Access Compliance Report

Public Rights-of-Way

(Curb Ramps)

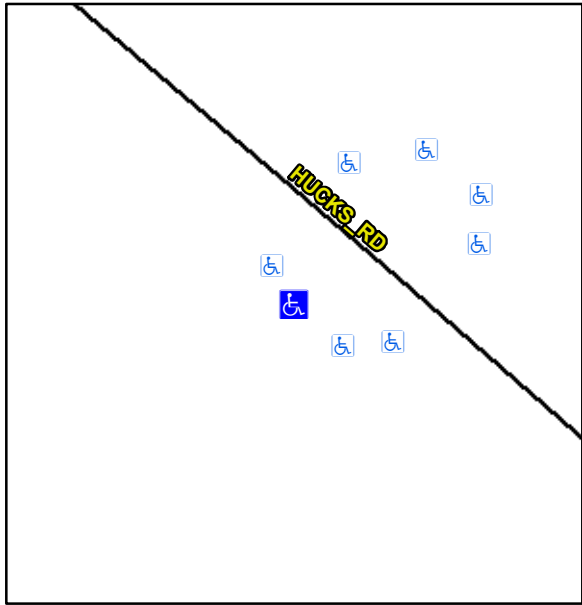
N/A		Flare Traversable LT?		N/A		N/A		Flare Traversable RT?		N/A	
						Yes		Landing Length (in)		60.5		Yes		DWS Provided?		Yes	
						Yes		Landing Width (in)		59.0		Yes		DWS Contrast?		Yes	
		No		Landing Slope (%)		5.5		Yes		DWS Length (in)		24.0					
		Yes		Landing X Slope (%)		3.0		Yes		DWS Full Width?		Yes					
		N/A		Landing Curb? (Y/N)		N/A		Yes		DWS Offset LT (in)		35.0					
		N/A		Shared Landing?		No		Yes		DWS Offset RT (in)		1.0					
		Yes		Gutter Ponding?		No		No		Gutter Slope (%)		6.8					
		Yes		Gutter Lip Ht (in)		0.0		Yes		Gutter X Slope (%)		3.9					
		N/A		Painted X Walk1?		No				Road Slope (%)		0.8					
				X Walk 1 Direction		To SE				Road X Slope (%)		3.9					
				X Walk 1 Width (in)		N/A				Clear Space?		Yes					
				X Walk 1 Slope (%)		0.8		N/A		Clear Space to XWalk (in)		N/A					
				X Walk 1 X Slope (%)		3.9		Yes		Storm Grate/Utility Hazard?		No					
		N/A		Ramp inside XWalk1?		N/A				Storm Grate/Utility Type

Yes		Any Obstructions?		No						N/A					
				Obstruction Type				Yes		Surface Condition? (G/P)		Good					
								N/A		No		Curb Slope (%)		12.6			
		Total Cost:		\$		2350.00
